From: Warrior, Andrew
Sent: 20 February 2020 14:13
To: Kelsey Blain
Subject: RE: Listed Building Consent and Planning Application for Mount Misery Farm, Hackness

Project
Mount Misery Farm

Content
Yorkshire Light Window Details and Sections

K. Blain

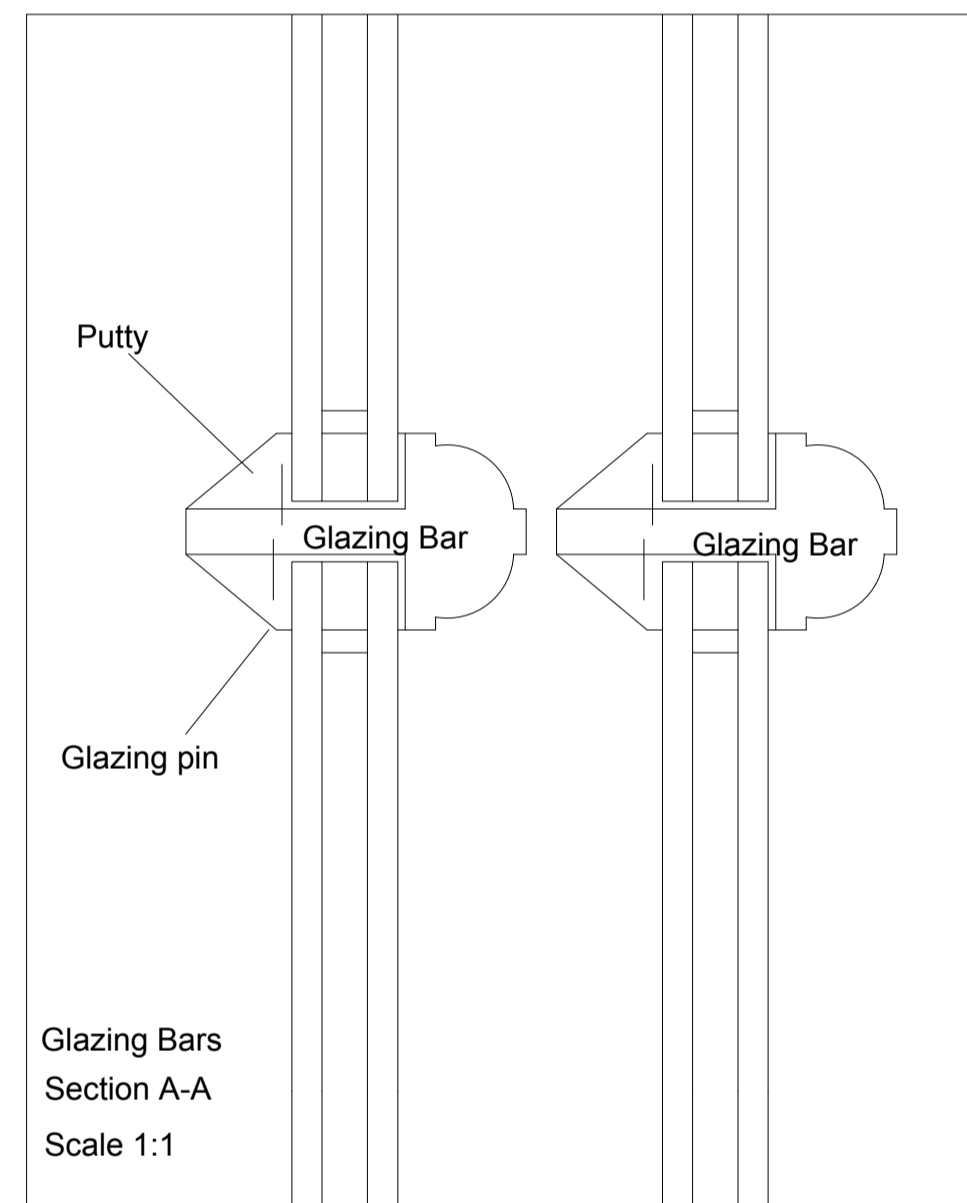
Thank you for your response. Please find attached a plan from a recent application which includes the details requested by the Building Conservation Officer. The Building Conservation Officer has also stated that they will accept 26mm glazing bars if other details (shown on the attached plan) could be replicated. They have requested that the details and approach also be replicated in the casement window.

Furthermore, whilst we appreciate the casement window being amended to a fixed sash, may I request that the design of this sash be amended to replicate that of the sashes on either side. This will remove the thick transom from the central sash which is the non-traditional element within this window.

Caseament window:

- Omission of the central top opening section which isn't a traditional arrangement. Central pane should be fixed with just the two side panes opening.
Top casement sash can be fixed

- Use of glazing putty to hold the glass, not beads. You can get putty which is compatible with d/g units.
Although timber beading would be more suitable for double glazed units and the profile would look like putty as the timber beading in the photo you provided (Attached) I would be able to specify putty

- Reduction in the size of the glazing bar, down to 22mm if possible?
As we are fitting double glazed units it would not be possible to reduce the size of the glazing bars. The double glazed unit spacing bar has a depth of 10mm, the rebate and the glass should have a 2mm clearance this is why the rebate depth has to be 12mm. When fitting beads to hold the unit in place the feather has to be sufficient to provide a secure fixing for the pins as you have requested putty the thickness of the feather is crucial to provide a safe and secure fixings.

- Omission of the drip moulds.
The drip mould is good practise but will be removed
- Could consideration be given to use of a leaded cill, rather than a projecting cill – see example attached.
The projecting cill is preferred as it will allow water to drain away from the building and prevent the water from traveling back in to the building by capillary action.

I also omitted to say the casement windows will be hung on butt hinges and they will be held shut by traditional window stays and fasteners.

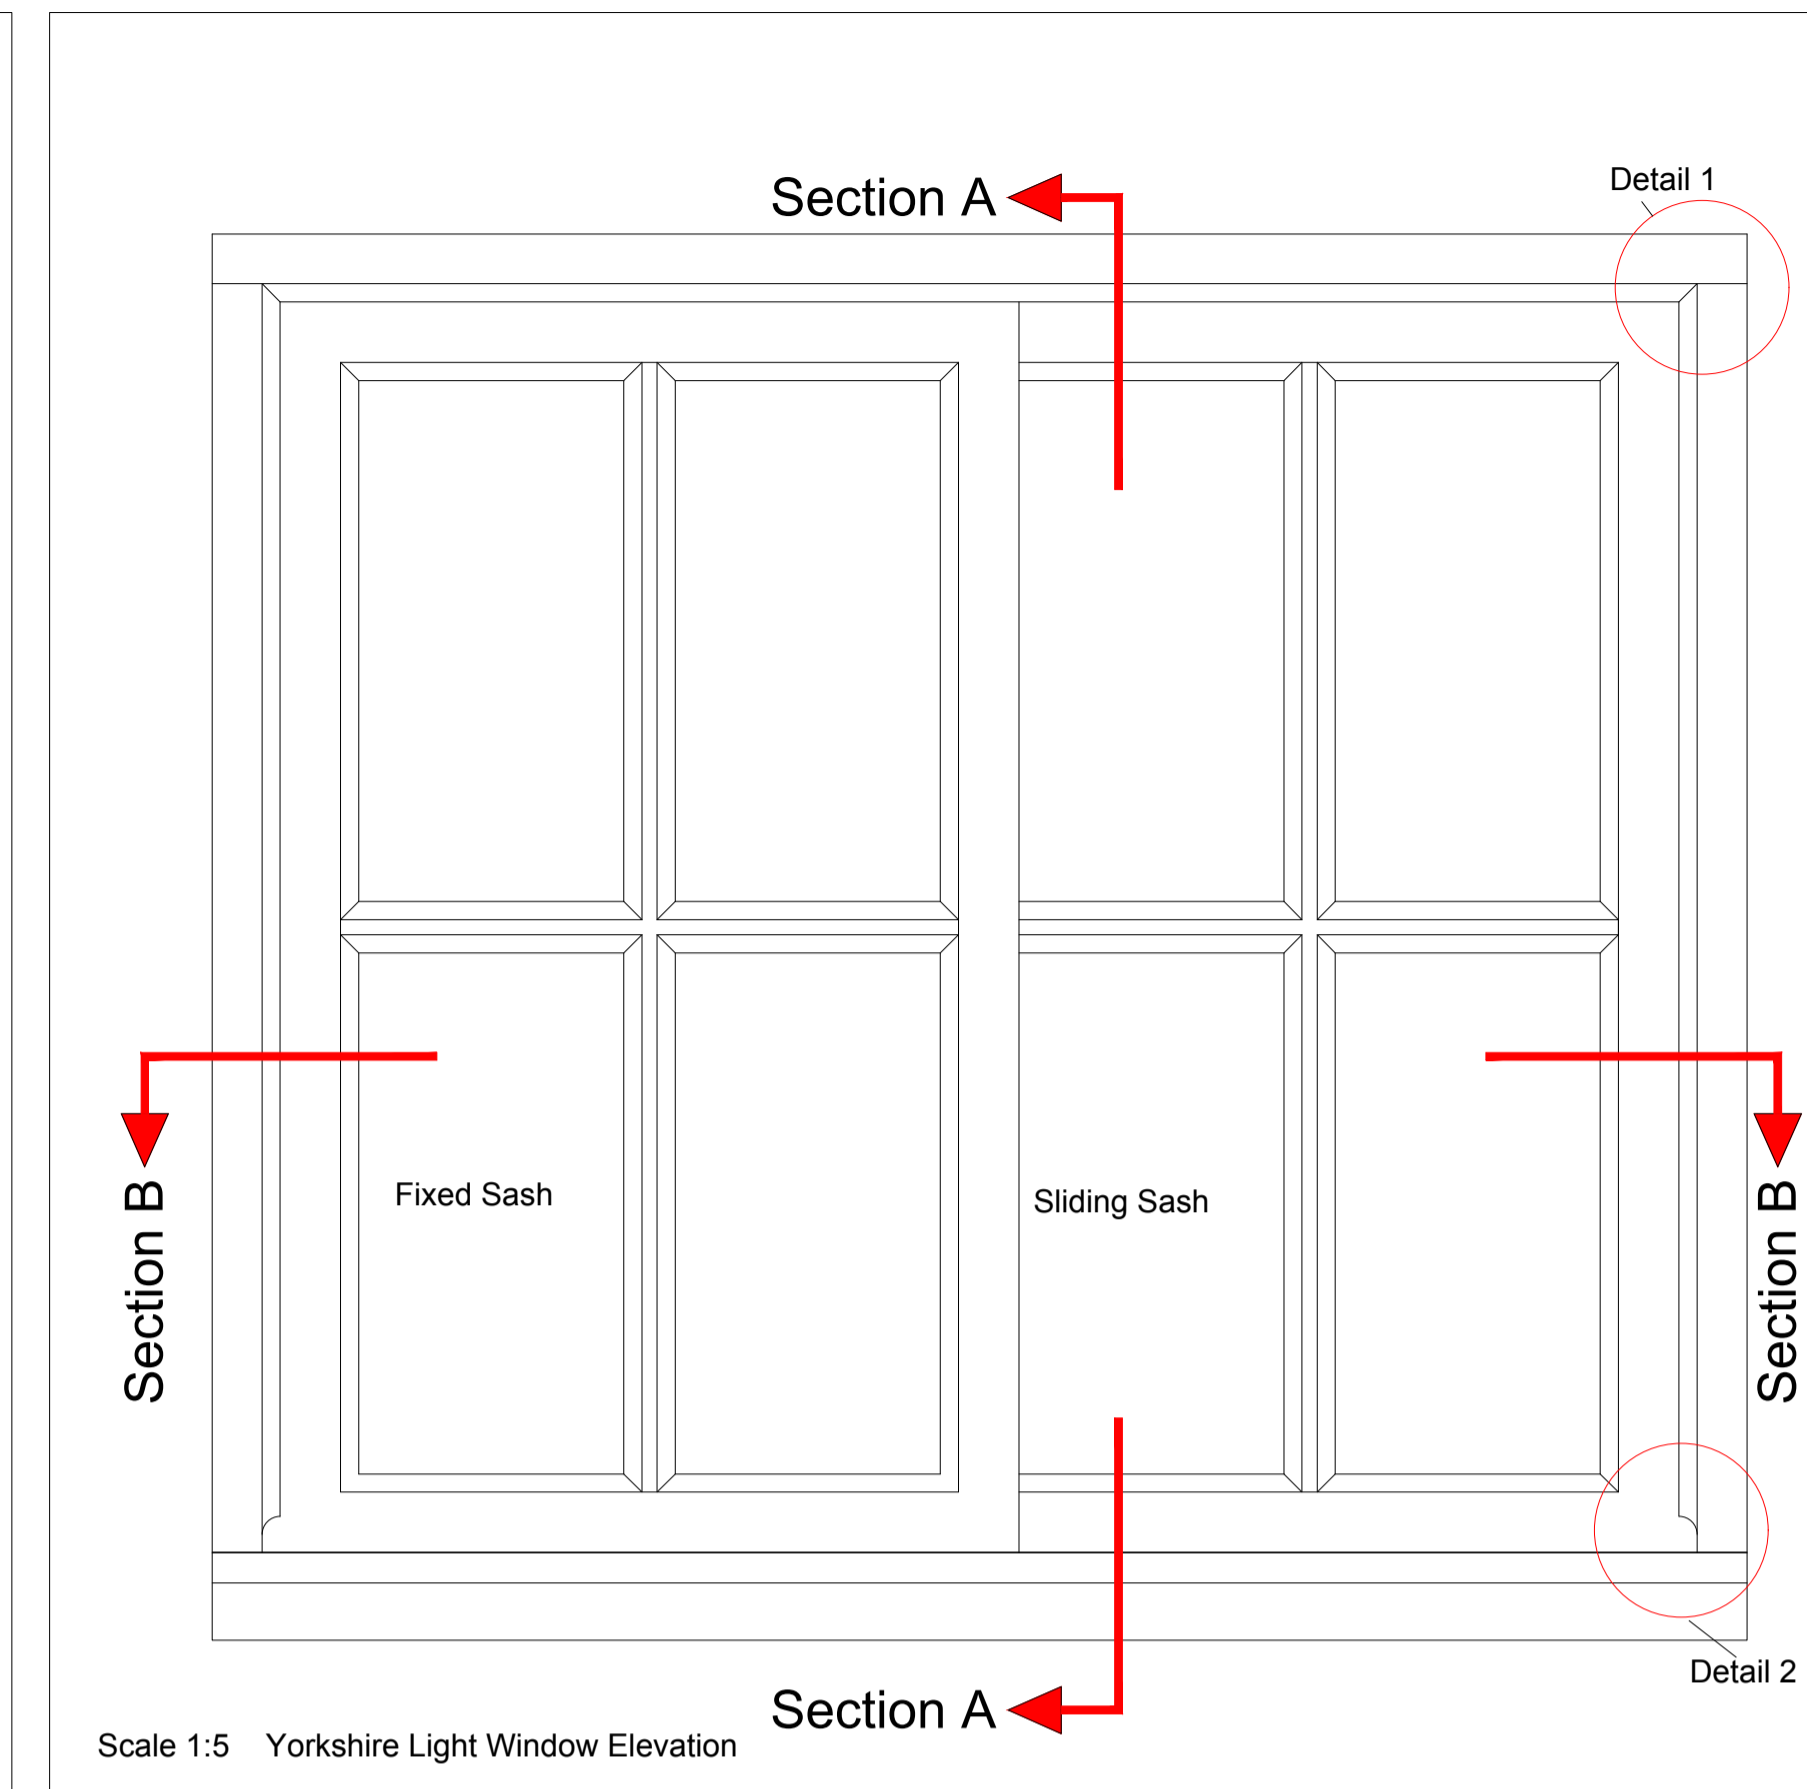
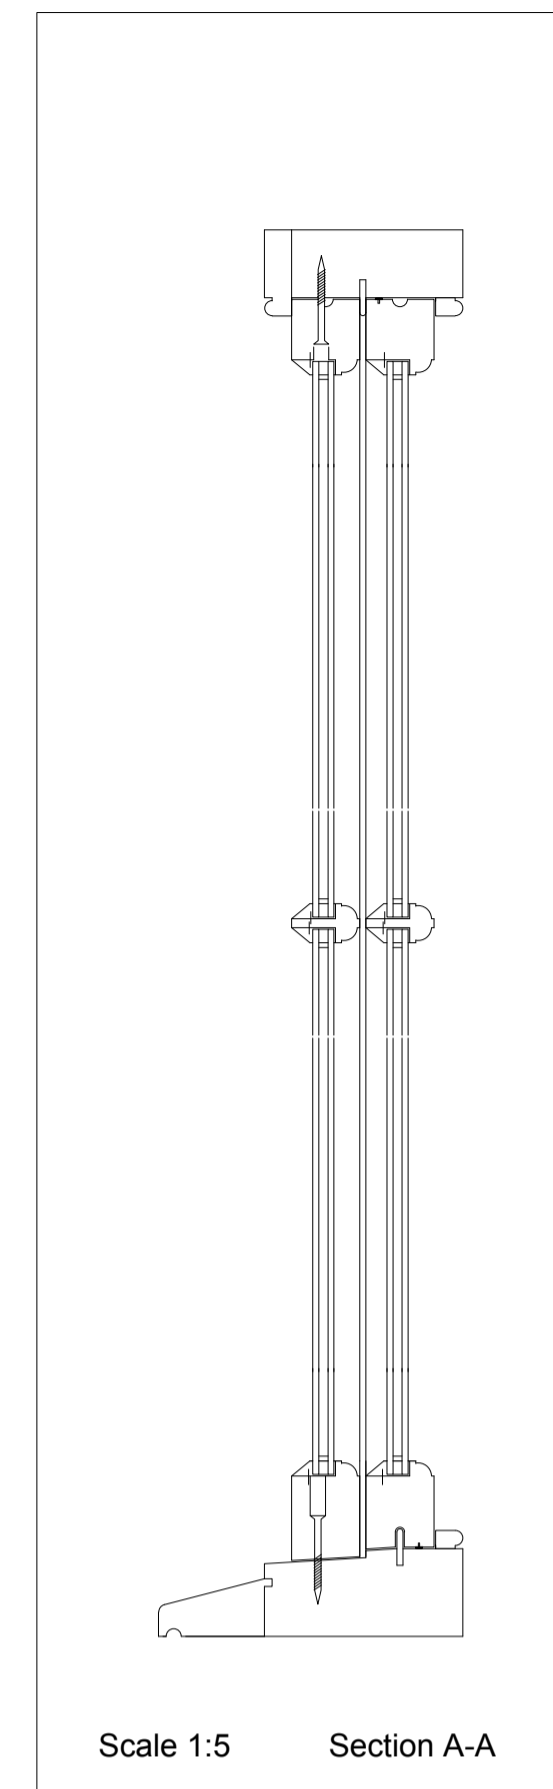
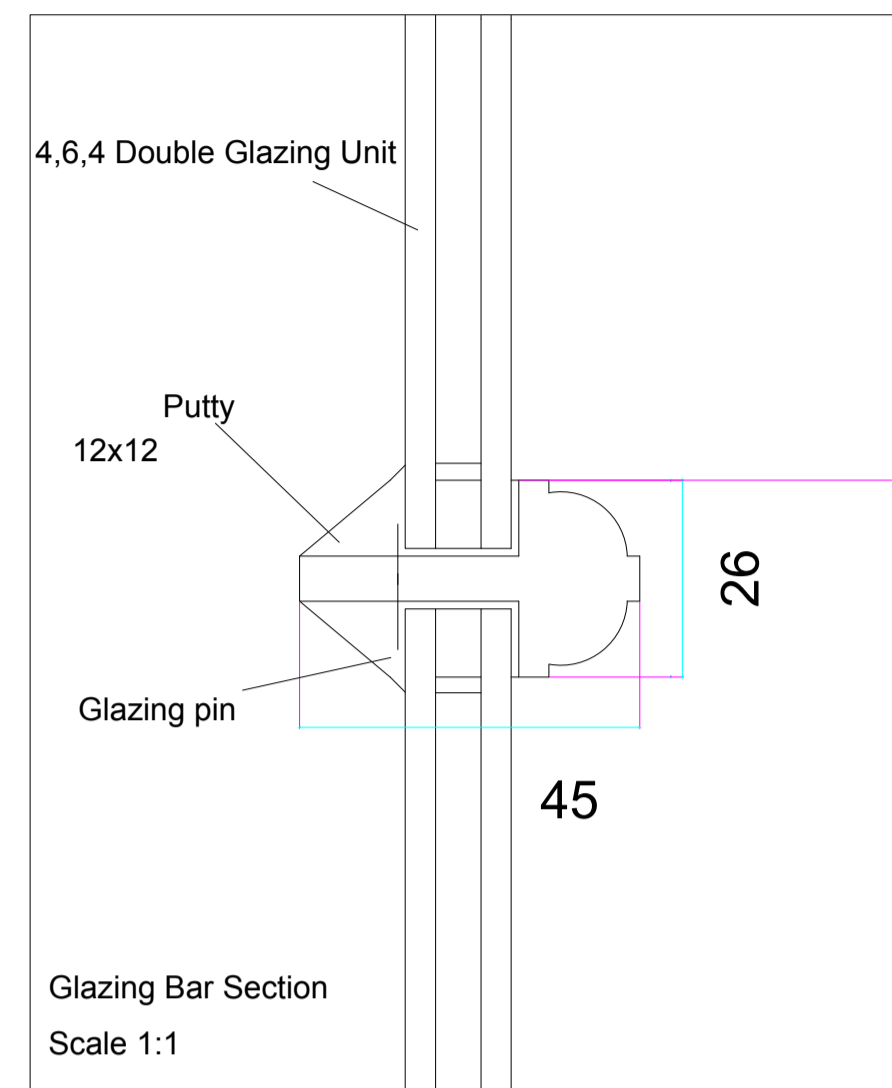
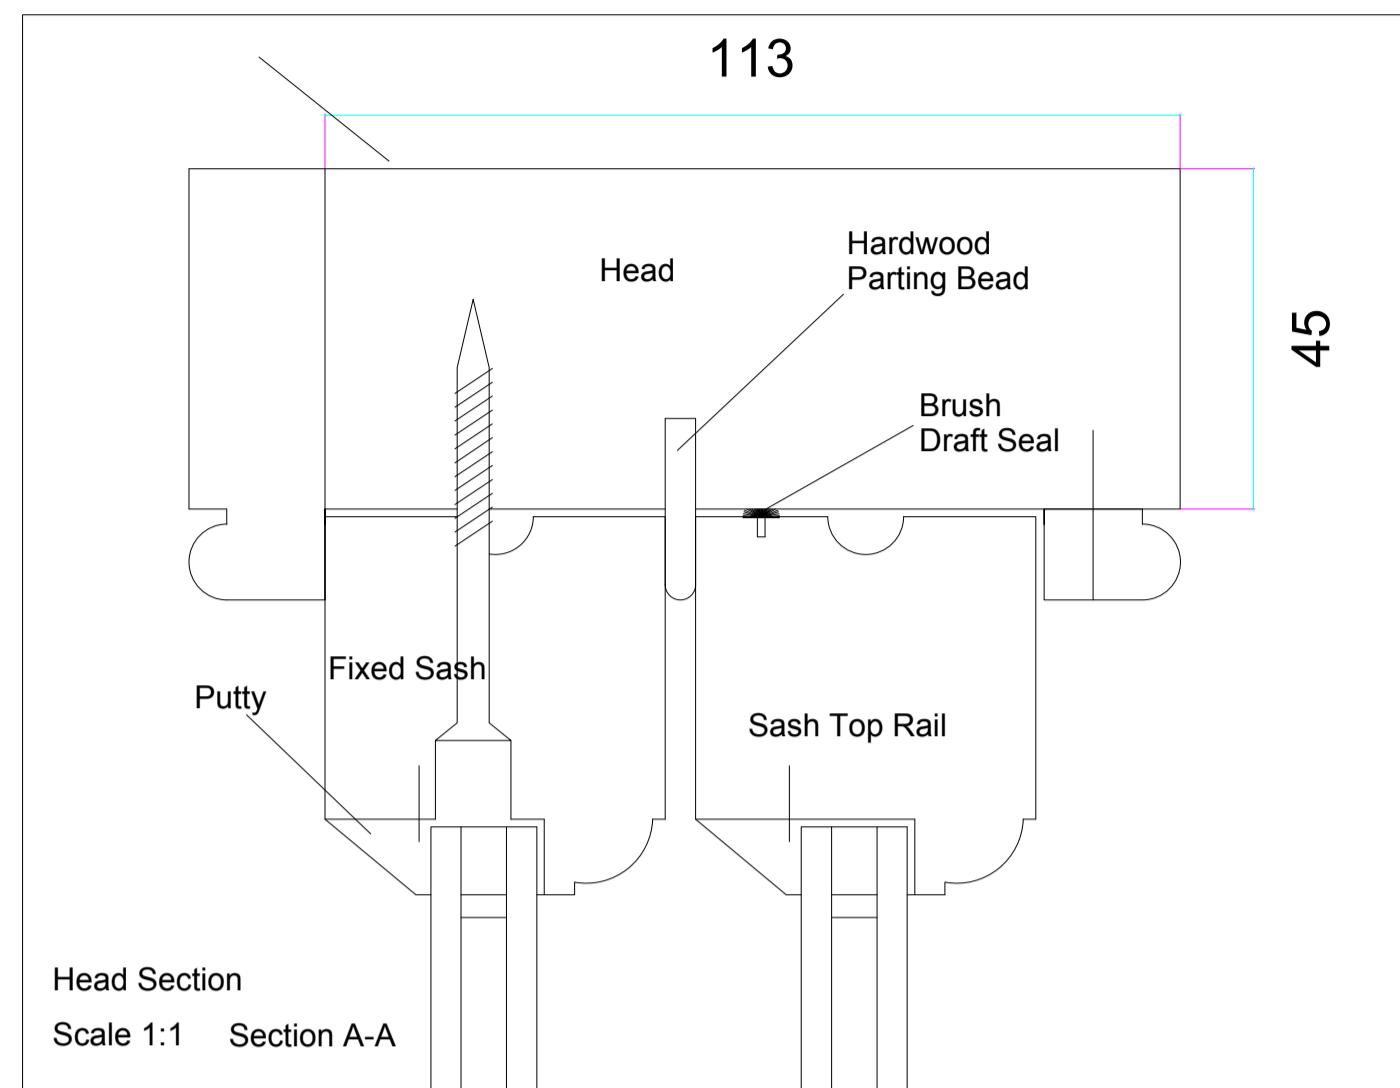
Yorkshire s/s

- Glazing to be putty pointed, not beads as mentioned above.

- Reduction in size of glazing bar, 22mm if possible?

- Could consideration be given to use of a leaded cill, rather than a projecting cill – see example attached

The Building Conservation Officer has also stated a preference for the left hand ground floor window to be a Yorkshire Sliding Sash as this would lend itself well to the existing arrangement.

Although timber beading would be more suitable for double glazed units and the profile would look like putty as the timber beading in the photo you provided I would be able to specify putty

As we are fitting double glazed units it would not be possible to reduce the size of the glazing bars. The double glazed unit spacing bar has a depth of 10mm, the rebate and the glass should have a 2mm clearance this is why the rebate depth has to be 12mm. When fitting beads to hold the unit in place the feather has to be sufficient to provide a secure fixing for the pins as you have requested putty the thickness of the feather is crucial to provide a safe and secure fixings.

The projecting cill is preferred as it will allow water to drain away from the building and prevent the water from traveling back in to the building by capillary action.

We have no plans to change the window to the left hand side (Bathroom window) as this is not in need of repair or replacement but when it is we would consider matching the kitchen window.

The kitchen window will remain as a casement window as drawings and the bedroom window will be changed to a Yorkshire light

The sliding sash to the Yorkshire light will be secured by a fitch fastener.
